# Sydney Desalination Plant ("SDP") - Expenditure Review

Supplementary Report

Independent Pricing and Regulatory Tribunal ("IPART")

June 2023

Figure 3-1 – Relationship between power use and water production

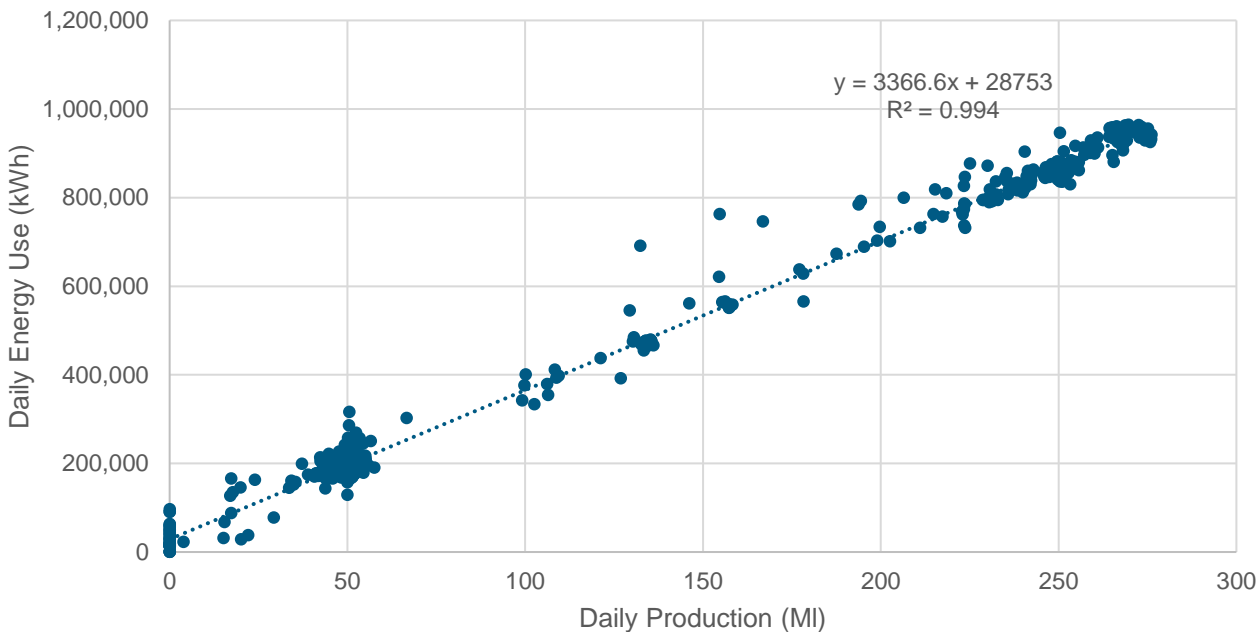
- *the draft decision is based on a line-of-best-fit using energy consumption from the 2017-23 regulatory period. SDP's concern is that the energy use during the 2017-23 regulatory period was based on the Plant's emergency response role, where only the three most efficient Reverse Osmosis (RO) trains were preferentially used on a temporary basis until the Plant was expected to shut down.<sup>44</sup> With the Plant now set to operate on a flexible full-time basis this is not a sustainable approach. To meet good industry practice, **we will need to undertake normal asset rotation among the Plant's 13 RO trains. In the absence of additional capital investment, this will increase the Plant's energy use during the 2023 Determination period relative to historical energy usage.***

- *Atkins recommendation is also below SDP's proposed benchmark energy volumes, because Atkins considers the design of the Plant (that relies on operational valve throttling to adjust pressure to the membranes) means that aging membranes will not have as great an effect on energy consumption as SDP proposed. SDP submits that **this view only applies to RO trains without trimmed impellers.** However, as noted above three out of 13 (23%) of the Plant's RO trains operate on trimmed impellers, which do not adjust pressure via operational valve throttling.*

We have considered these statements. However, it is clear that they do not affect our view of efficiency energy use. The recommendation is based on analysis of energy use across the full range of production levels as can be seen below.

We consider that no change in our recommendations is required.
